# MEAN WELL Enterprises Co., Ltd.

## Product Change Notice: Output cable change for GEM40/SGA60/ SGAS60 series

Date : 2022/04/15

**Change illustrations:**

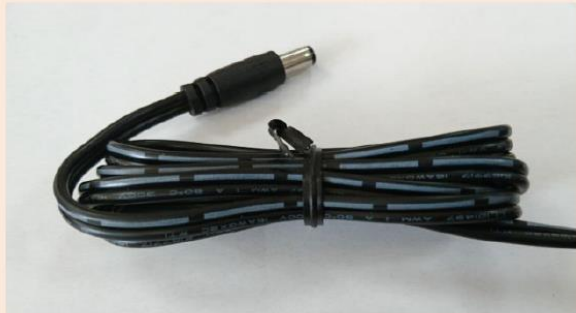
Difference between 2 versions	
Old Version	New Version
UL 1571 @14AWG (Thicker cable with round shape)	UL 2468 @16AWG (Thinner cable with flat shape)
